County of Bernalillo

RE: DRAINAGE REPORT FOR SANDIA HEIGHTS SOUTH UNIT 23
(LAS CASAS DE SAN RAFAEL SUBDIVISION) (D-23/D29)
ENGINEER'S STAMP DATED FEBRUARY 20, 1992

**REVISED
DRAINAGE REPORT
FOR
SANDIA HEIGHTS SOUTH
UNIT 23**

TERRAIN MANAGEMENT & PRELIMINARY GRADING/DRAINAGE PLAN

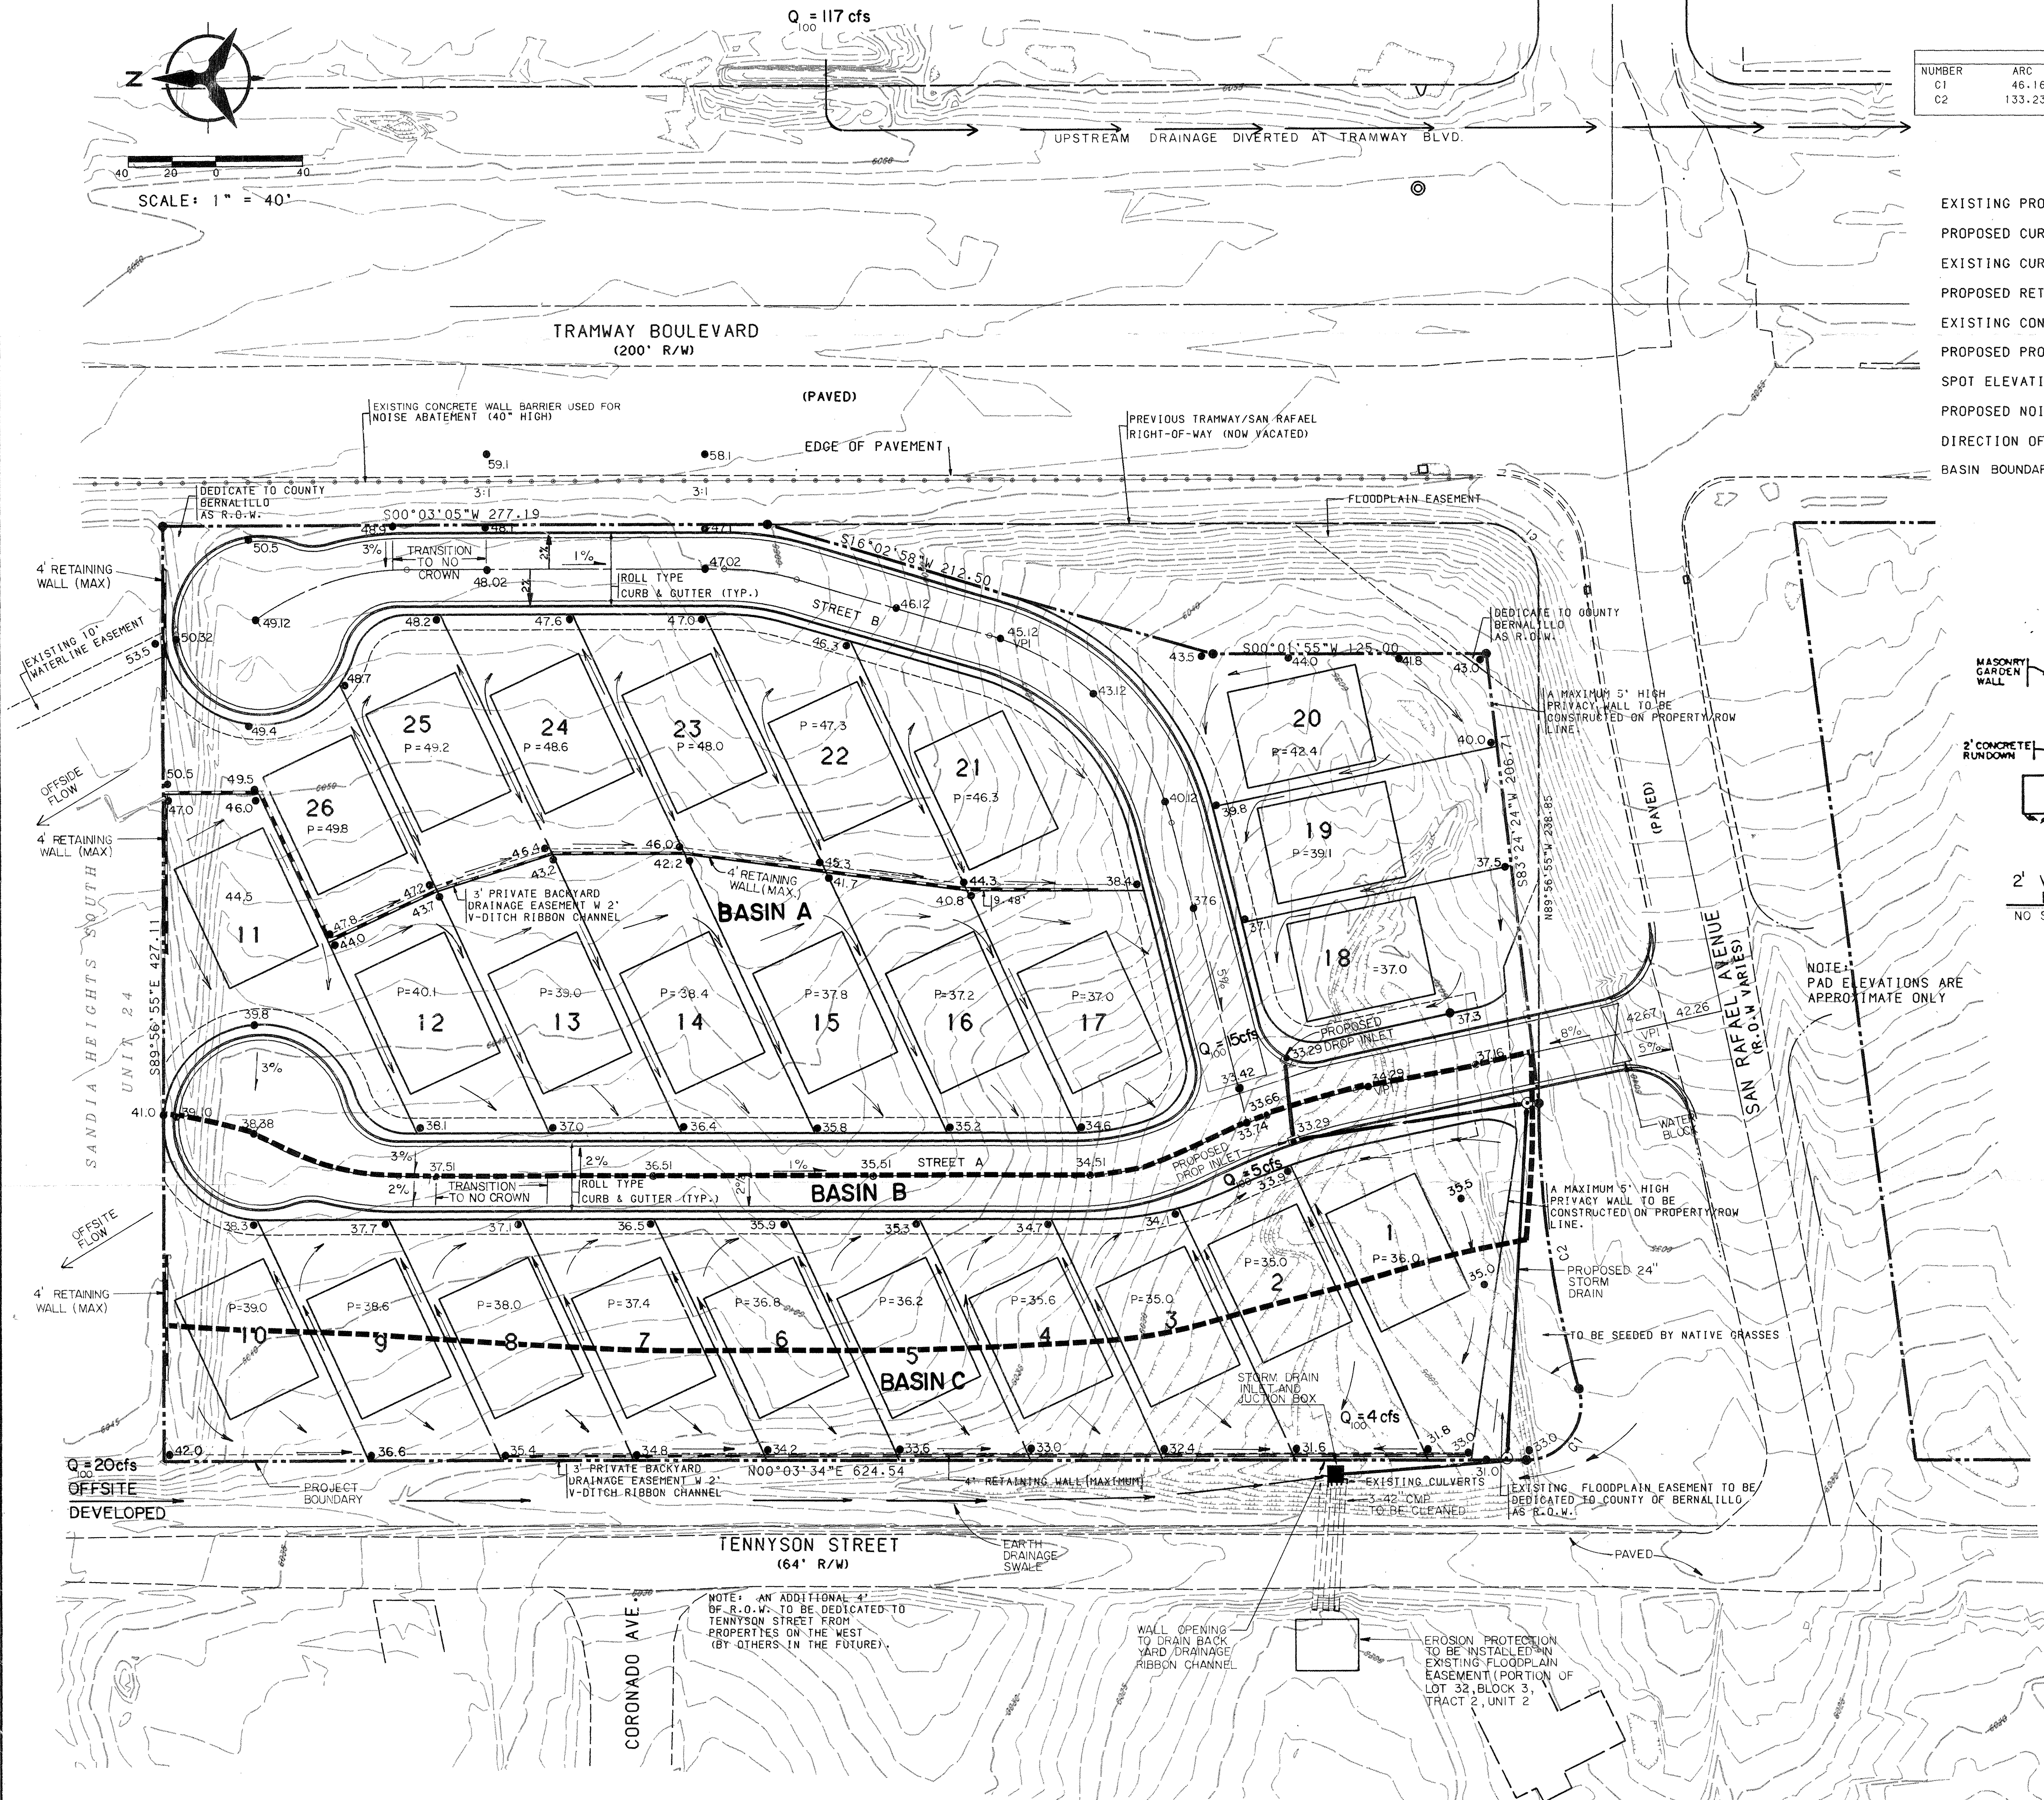
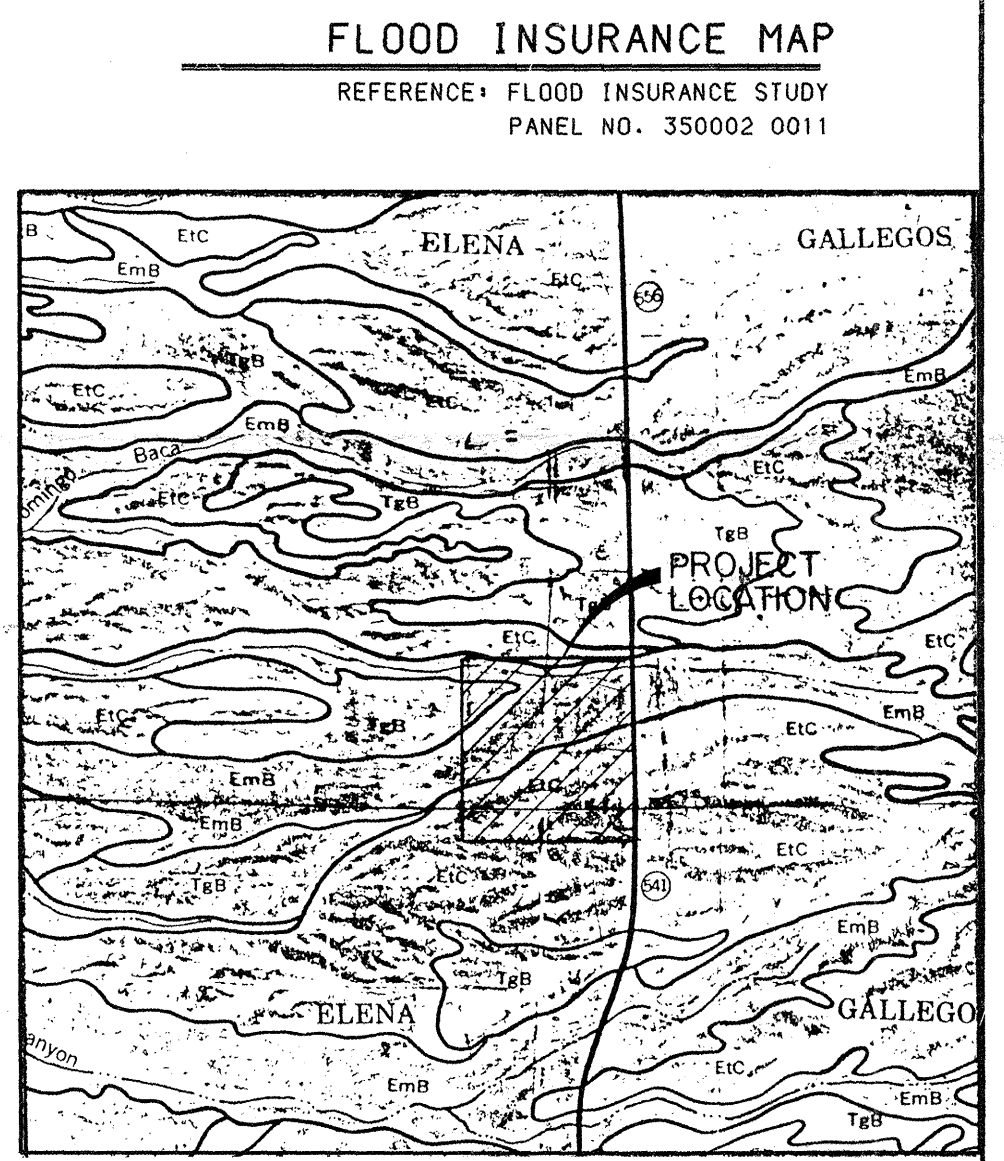
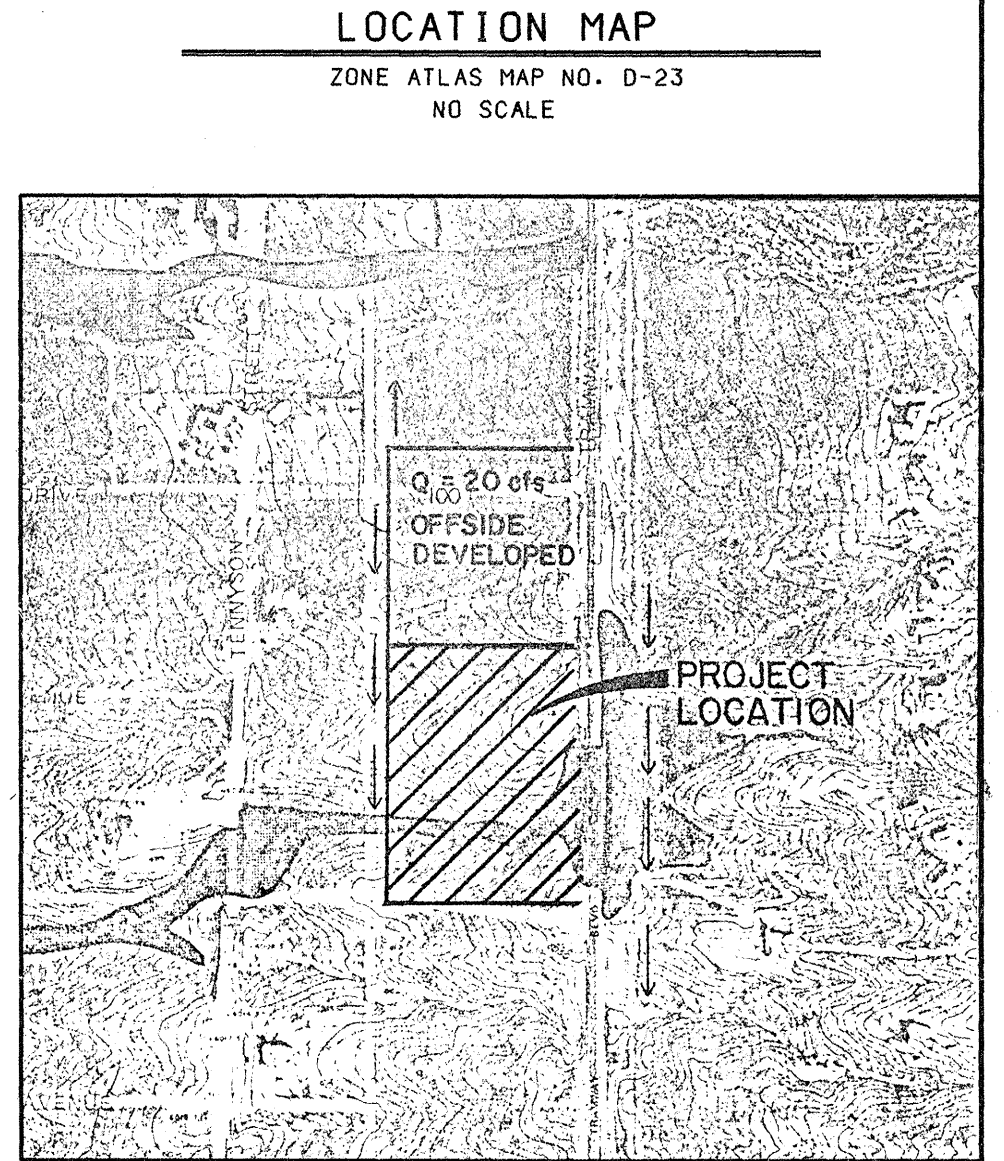
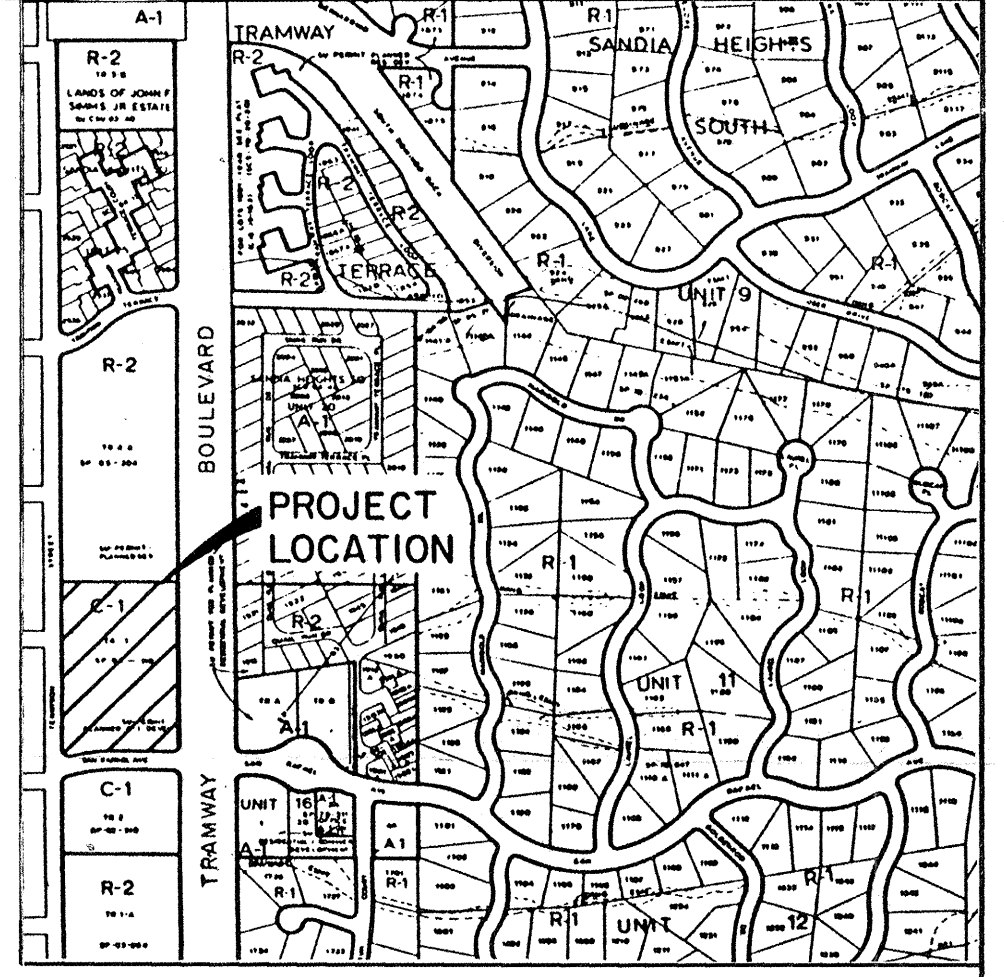
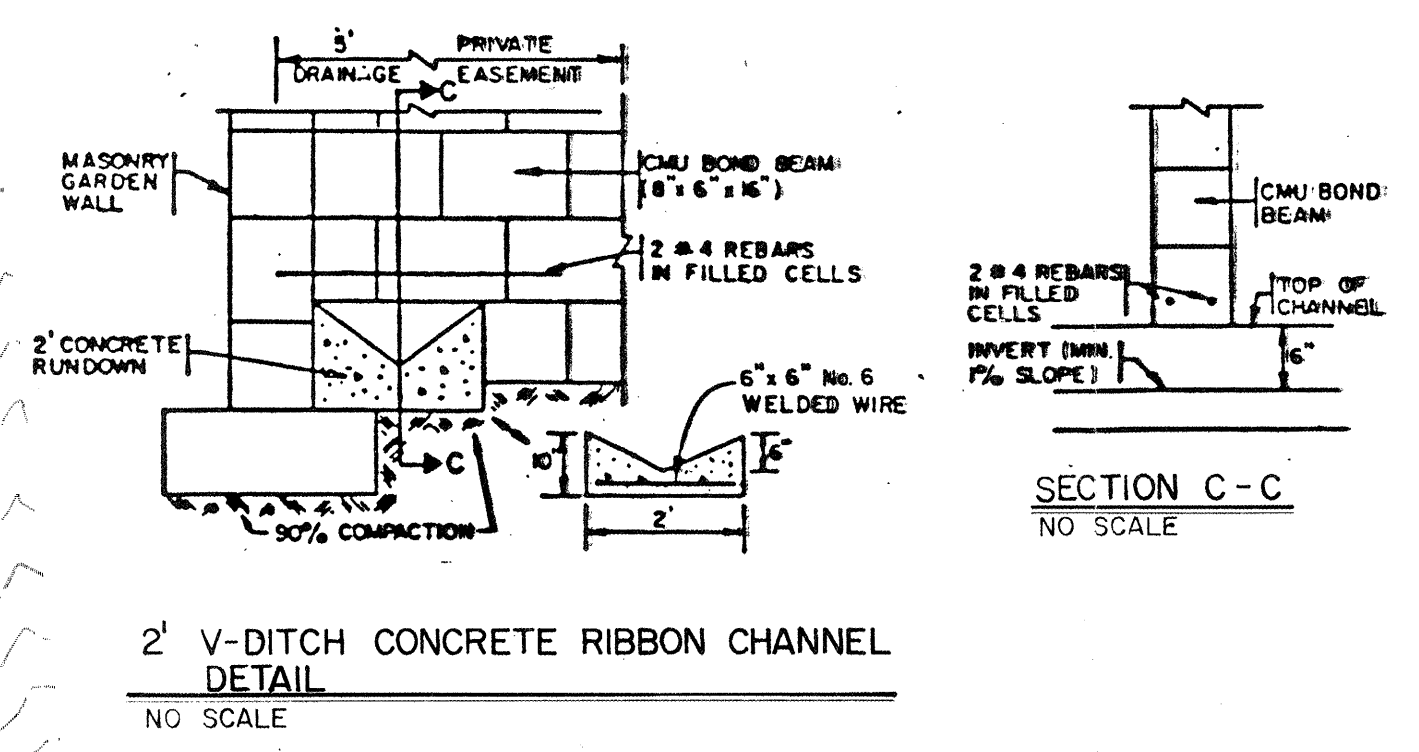
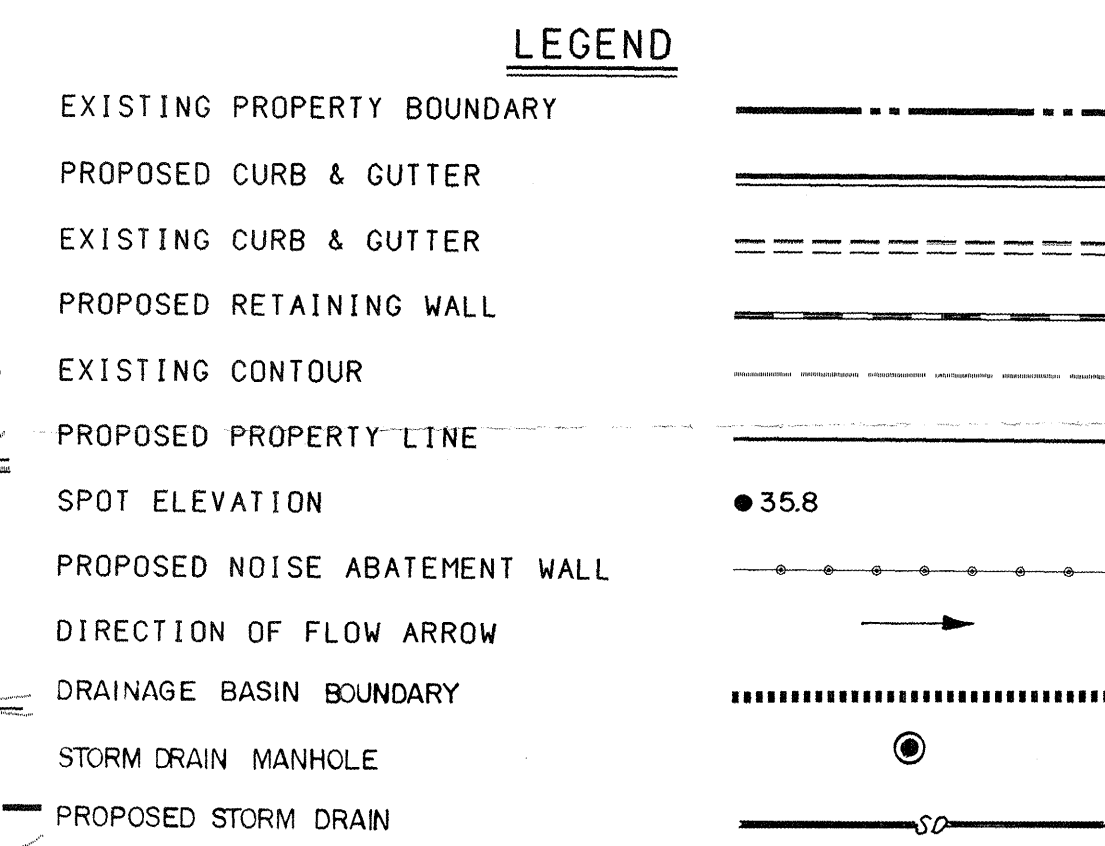
Until such time that an official Letter of Map Revision from FEMA is secured this property is likely to be subject to flood insurance requirements by the Flood Insurance Agency. Please be advised that FEMA has not reviewed the Letter of Map Revision request so this property could still be encumbered by a 100-year floodplain even with the diversion in place, due to all of FEMA's new criteria. Please add a note on the plat and drainage plan regarding this issue.
